Re: Catholic Archdiocese of Toronto Draft #3 Zoning Comments

We have reviewed Draft #3 and have the following comments.

3.1.1 - Accessory Buildings and Structures in Neighbourhood Low Zone – Table 4: Additional Accessory Building and/or Structure Standards

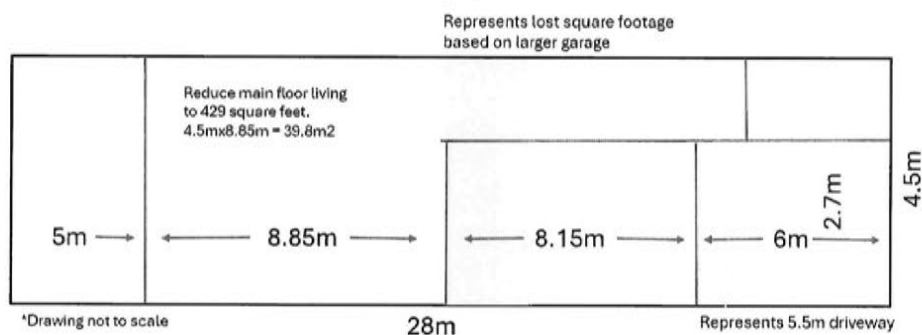
Yard & Building Standards	Draft #3	Should be:
Exterior Side Yard Setback (minimum)	3m	2m
Building Area (minimum)	22 sq m	<p>The same as the minimum parking space as defined in 4.3 - <i>Minimum Parking Space Sizes</i></p> <p>If a rowhouse lot size can be a minimum of 4.5m with a 60% driveway, to achieve a 22 sq m garage building area the garage dimensions would have to be 2.7m x 8.15m.</p> <p>The current lot length is 28m. With setbacks in front (6m), back (5m) we are left with 8.85m significantly reducing our interior square footage, a costly redesign of our plans and a generally poor choice in terms of reducing livable interior space.</p>

Collector Roads – Lally Terrace, McAush, Prince William Way, Terry Fox Drive

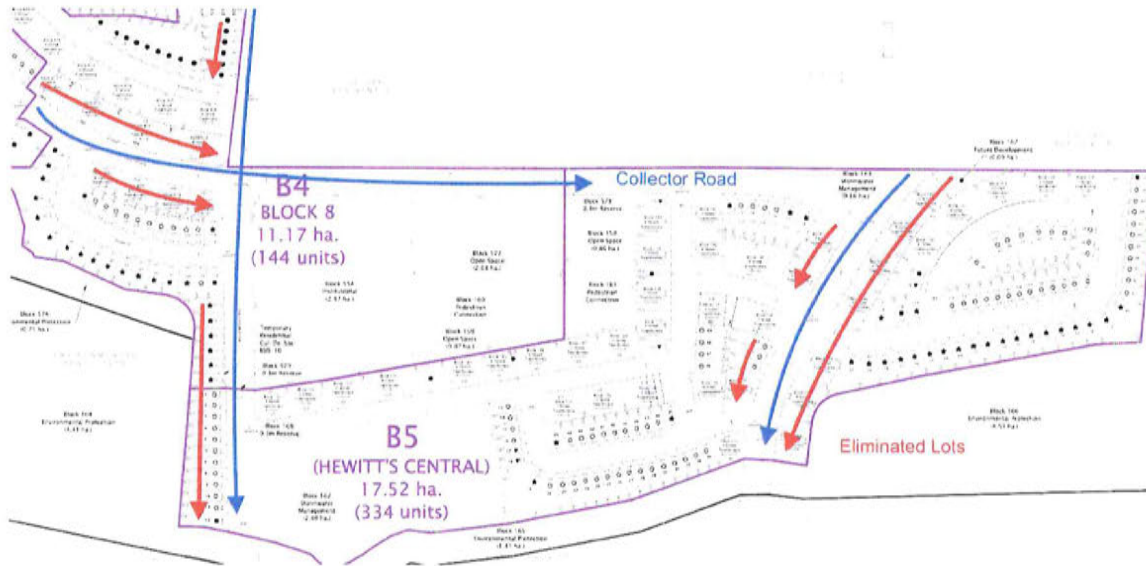
Note: Detached, Semi-Detached, and Rowhouse, On-Street and Back-to-Back buildings are only permitted when fronting onto Local Roads

ISSUE: This has significant density and cost implications for ground-oriented development. Every site designed in Hewitt's so far has had residential lots fronting collector roads.

The map below shows lots that would not exist under this rule. The current subdivision design for future Hewitt's has lots fronting on all 4 collector roads listed above and eliminating the ability for front facing lots will significantly reduce density and require a complete overhaul of the subdivision design. All of which will incur major engineering and design costs.

SOLUTION: Remove entirely

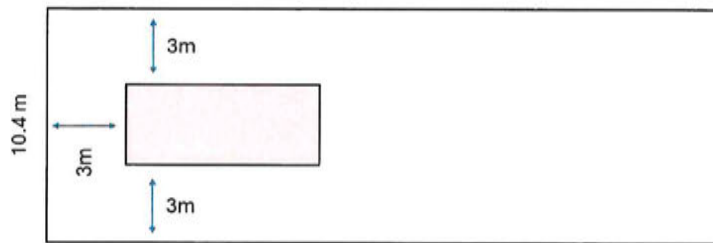
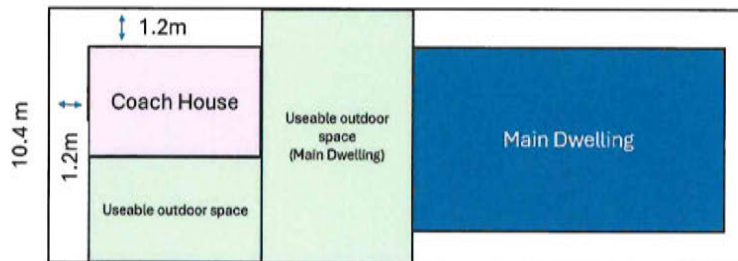
ISSUE: Current approved plans include lots specifically designed to include a Coach House. Picture below demonstrates the impact these setbacks will have on design and buildability on our already approved Site Plan.

The setbacks would eliminate most semi-detached and rowhouse lots given their minimum lot widths. Additionally, a standard 10.4m lot would allow for a maximum 4.4m wide coach house centered directly in the middle of the backyard. The design options with this restriction limit functionality and desirability of the dwelling. Further, this limits both dwelling units' access to a usable backyard area. By reducing the setback to 1.2m it allows for more design flexibility and more importantly, access to a usable outdoor space. See images below.

SOLUTION: Reduce setbacks to match Detached Garage rear and interior setback of 1.2m.

**Red colour shows
all the NL1, NL2 and
NL3 zones in the east end**

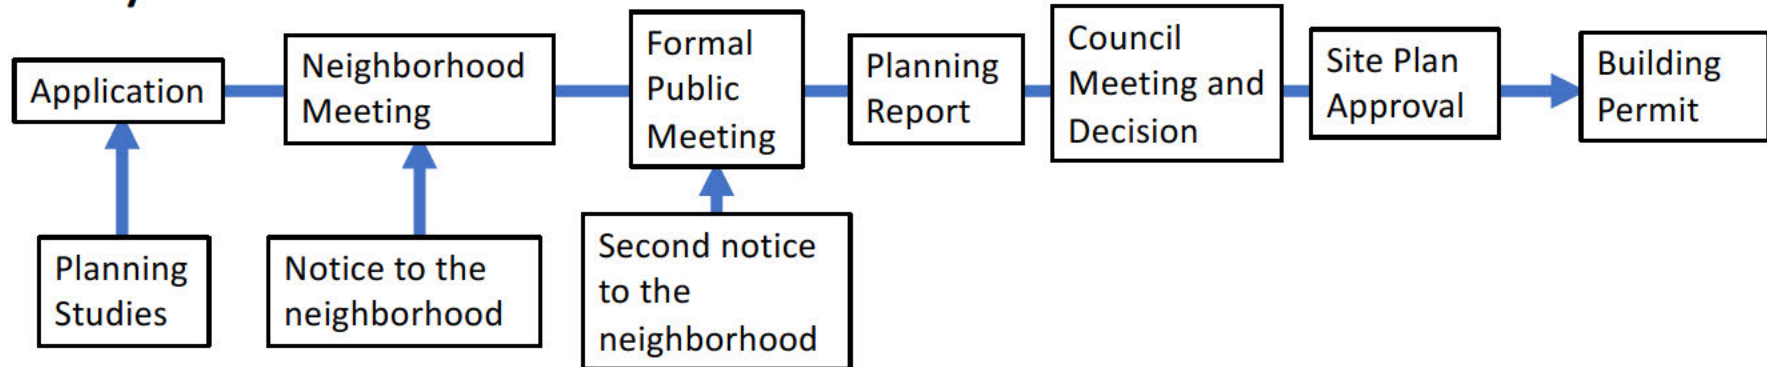
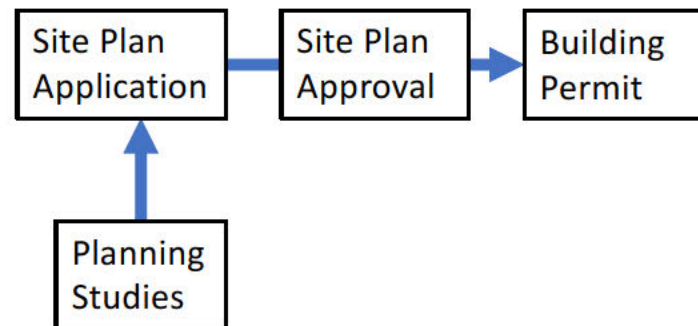
- It would pre-zone most of the residential land in the City for uses that today would require a rezoning process all the NL zones
- Four storey apartments and townhouses will be permitted as-of-right in all of the low density residential areas of the City
- That zoning will apply to approximately 40,000 dwellings in Barrie
- Building that form of housing now requires a rezoning
- If Draft 3 is approved that will not be the case

Pre zoning the neighborhoods does not conform to the Official Plan

**Red colour shows
all the NL1, NL2 and
NL3 zones in the east end**

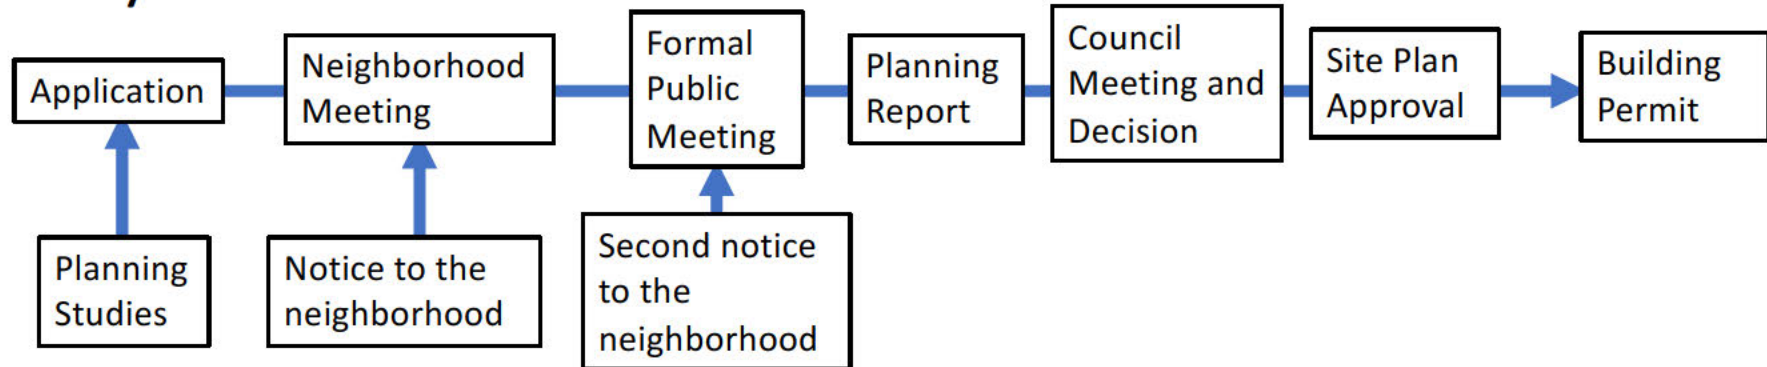
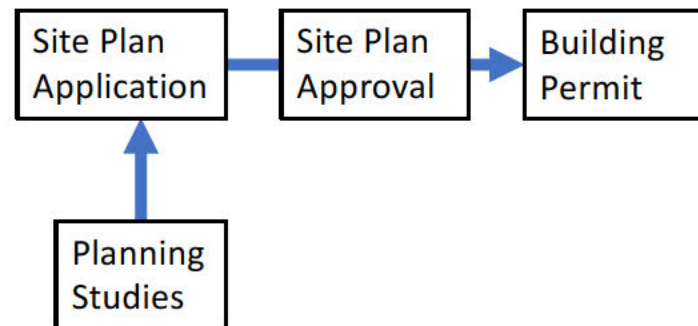
- It would pre-zone most of the residential land in the City for uses that today would require a rezoning process all the NL zones
- Four storey apartments and townhouses will be permitted as-of-right in all of the low density residential areas of the City
- That zoning will apply to approximately 40,000 dwellings in Barrie
- Building that form of housing now requires a rezoning
- If Draft 3 is approved that will not be the case

Pre zoning the neighborhoods does not conform to the Official Plan
